Sfernice-CH02016 & CHA02016 Backside color change

Description of Change: Blue Ink instead of Green Ink on the rear side of the CH02016/CHA02016 resistor.

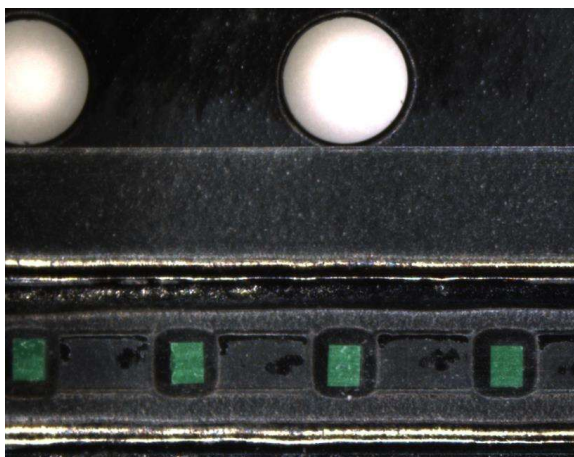
Reason for Change: REACH compliant.

Expected Influence on Quality/Reliability/Performance: No influence on reliability of the component: The blue ink is not conductive. CH02016 with active face down in tape and reel (F or M termination) have back-side color inked to indicate right orientation and facilitate the positioning in the Vishay tape and reel process.

CH02016 with active face down in tape and reel (F or M termination) have back-side blue inked to indicate right orientation and facilitate the positioning in the Vishay tape and reel process.

- Before : Green color

- Today : Blue color
